Access Compliance Report

Public Rights-of-Way

(Curb Ramps)

Intersection ID: 8113	Main Street: ORR_RD	Cross Street: GRIER_RD	Location: W
ADA ID: 70199F64E0DA	Ramp Type: Perp	Initial Pass/Fail: Fail	Overall Compliance: No
Severity Score: 13.75			
Codes/Mitigation Info/Possible Solution		Field Measurements/Component Compliance

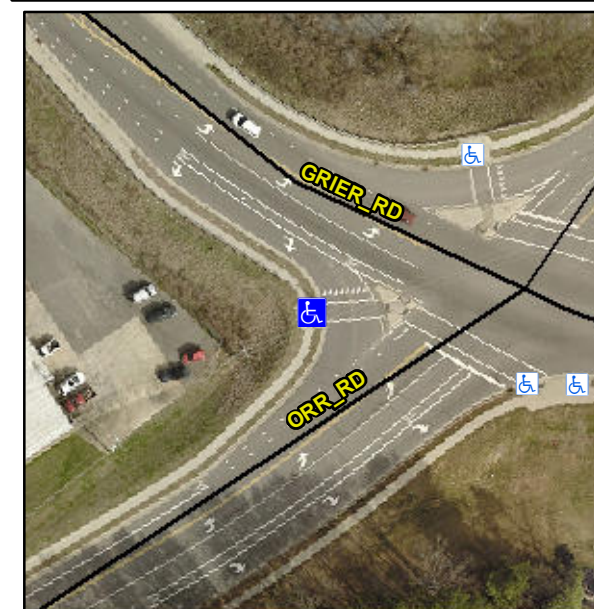
Not Found, R304.2.2, R304.5.3

Compliance	Description	Data	Compliance	Description	Data
N/A	Ramp Length (in)	48.0	No	Ramp Slope (%)	9.9
Yes	Ramp Width (in)	48.0	No	Ramp XSlope (%)	4.1
N/A	Flare Type LT	N/A	N/A	Flare Type RT	N/A
N/A	Flare Slope LT (%)	N/A	N/A	Flare Slope RT (%)	N/A
N/A	Flare Traversable LT?	N/A	N/A	Flare Traversable RT?	N/A
N/A	Landing Length (in)	N/A	N/A	DWS Provided?	N/A
N/A	Landing Width (in)	N/A	N/A	DWS Contrast?	N/A
N/A	Landing Slope (%)	N/A	N/A	DWS Length (in)	N/A
N/A	Landing X Slope (%)	N/A	N/A	DWS Full Width?	N/A
N/A	Landing Curb? (Y/N)	N/A	N/A	DWS Offset (in)	N/A
N/A	Shared Landing?	N/A			
N/A	Gutter Ponding?	N/A	N/A	Gutter Slope (%)	N/A
N/A	Gutter Lip Ht (in)	N/A	N/A	Gutter X Slope (%)	N/A
N/A	Painted X Walk1?	Yes	N/A	Painted X Walk2?	N/A
	X Walk 1 Direction	To SE		X Walk 2 Direction	N/A
N/A	X Walk 1 Width (in)	105.0	N/A	X Walk 2 Width (in)	N/A
	X Walk 1 Slope (%)	1.9		X Walk 2 Slope (%)	N/A
	X Walk 1 X Slope (%)	0.4		X Walk 2 X Slope (%)	N/A

Remove & Replace Entire Ramp.
